## Zoning Challenge and Appeal Form (for approved applications)

BIS Job Number 121190200

Street Name West 66th Street

RE: Zoning Challenge  
36 West 66<sup>th</sup> Street  
Block 1118, Lot: 45  
Job No: 121190200

*Approximate building massing annotated by use*

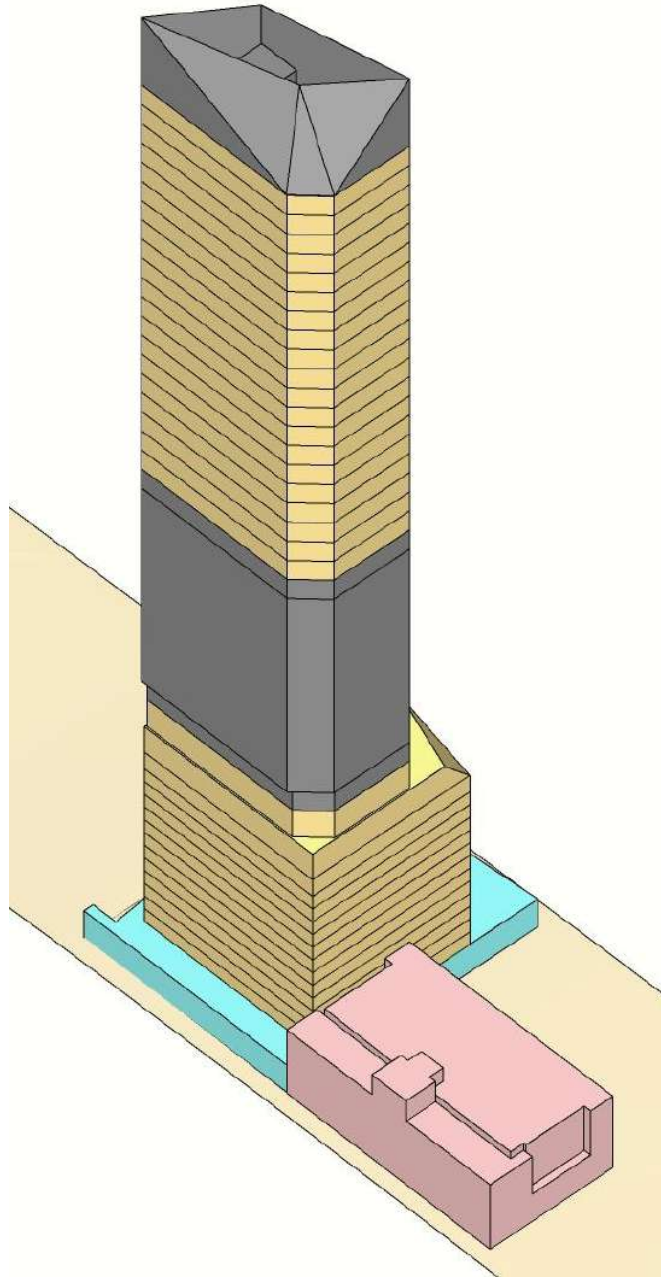
The proposed building has an atypically large mechanical void. The following is a 3D model of the proposed building and the building to stay on the zoning lot, based upon information provided in the ZD1:

The mechanical portions of the proposed building are shown in gray, residential in yellow, commercial in pink, and community facility in blue. A large interbuilding void starts on the 18<sup>th</sup> floor and extends 161 feet to the next story, the use of which is claimed to be accessory building mechanical. While there may be some mechanical equipment placed on the floor of this space, it appears that the primary use of the floor is to increase the height of the tower floors above it. There are also mechanical floors on the 17<sup>th</sup> and 19<sup>th</sup> floors but these have more typical floor-to-floor heights.

*Actual tower-on-base proposal at 249 E. 62<sup>nd</sup> Street*

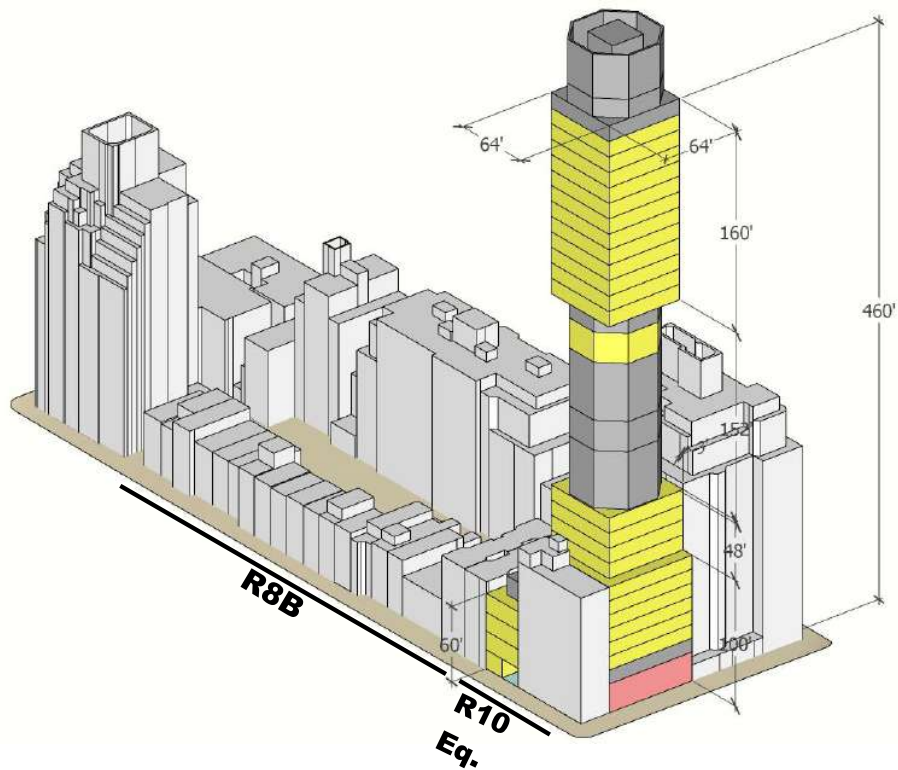
If the applicant's interpretation were correct, then there is no way that this CPC belief could be accurate. To demonstrate an even more absurd example of the applicant's interpretation, consider the following tower-on-base building proposed at 249 East 62<sup>nd</sup> Street.

This is another R10 equivalent tower-on-base building with a massive void. Here, the R10 equivalent portion of the lot extends only 100 feet from the wide street the tower faces. If all floor area on the zoning lot under 150 feet can be counted for bulk packing outside the R10 equivalent portion of the lot, and the tower is only counted on the R10 equivalent portion of the zoning lot, then the zoning lot can be expanded to cover much of the block. If that is done, then *all* floor area under 150 feet, with the exception of the ground floor of the new building will be in buildings to stay on the lot. This zoning lot would require no transfer of development rights and would not impair the future development potential of the existing developments in the height limited mid-blocks. The following shows how such a building might be massed out:

*Possible tower on base massing if the area for tower coverage is divorced from the area for bulk packing*

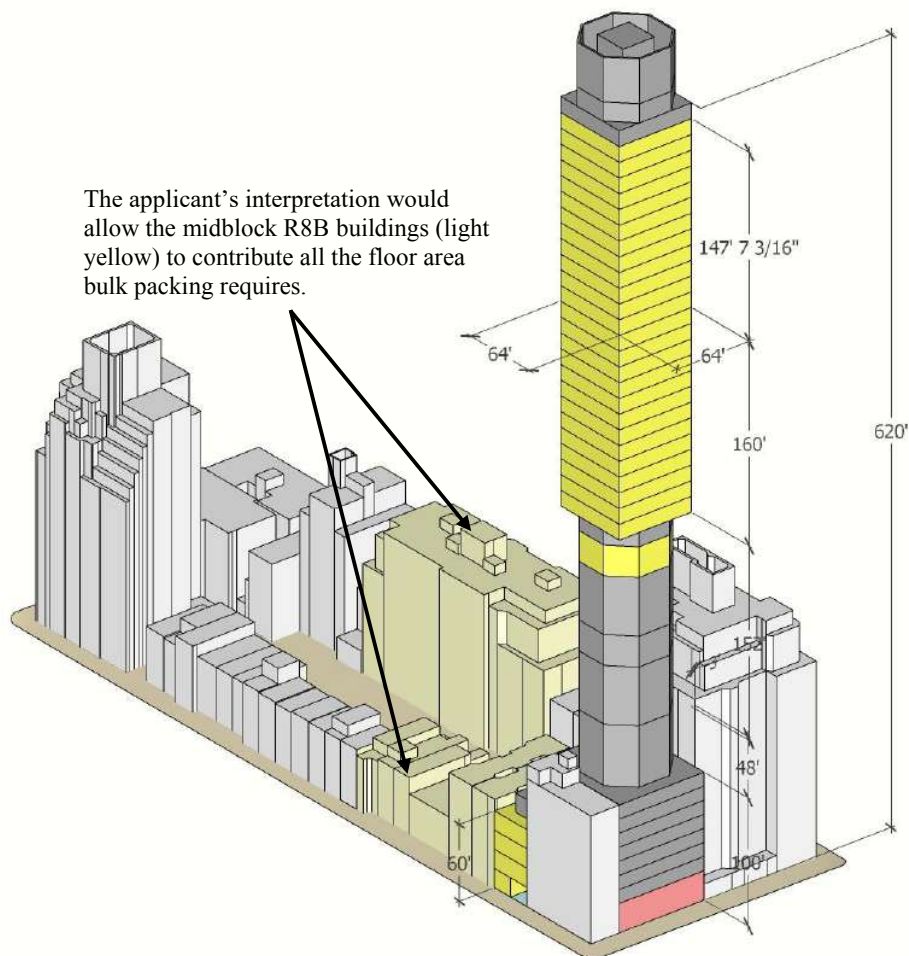
The existing buildings added to the zoning lot are shown in light yellow in the midblock. They contribute substantially all the floor area under 150 feet that this new building needs so that the floor area generated on its own lot can be placed at levels higher than 150 feet. In the prior example there were 13 residential floors over 150 feet. With this interpretation and large zoning lot, 26 residential floors in the main portion of the building are over 150 feet. This example shows expanded mechanical floors acting as a platform to raise the building to 150 feet so that the height can be maintained. It could have just as easily been a single floor designed to be 150 feet floor-to-floor, which while sounding absurdly unrealistic, is actually 11 feet shorter than what the applicant is actually proposing on the 18<sup>th</sup> floor of their building.

*Detail of plan showing the small inner court*

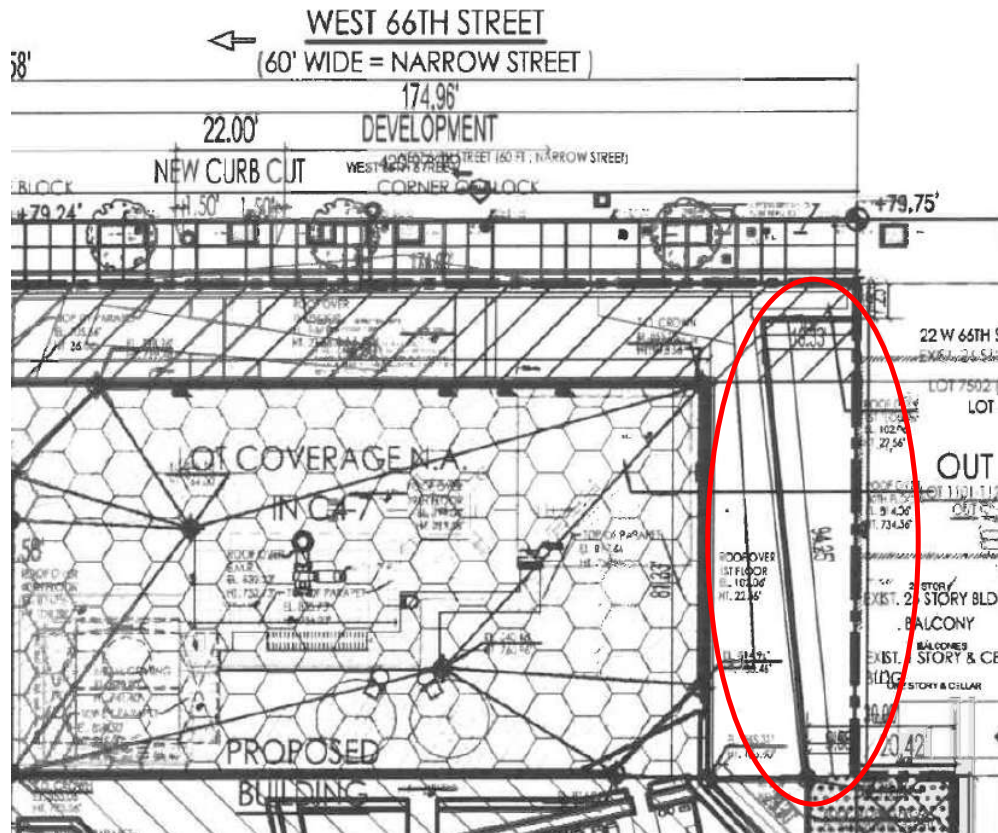
The ground level open space shown below is not a side yard because it does not extend to the front yard line. It is surrounded by building walls and a lot line, so therefore, it must be an inner court. While the numbers are hard to read on the ZD1, it appears that the plan shows the narrowest dimension for this small inner court to be just over nine feet.

The number shown appears to be 9.58 feet but that dimension is not taken at the narrowest location. ZR 23-851(b)(2) requires that this inner court be at least 10 feet wide. The zoning approval should be revoked.
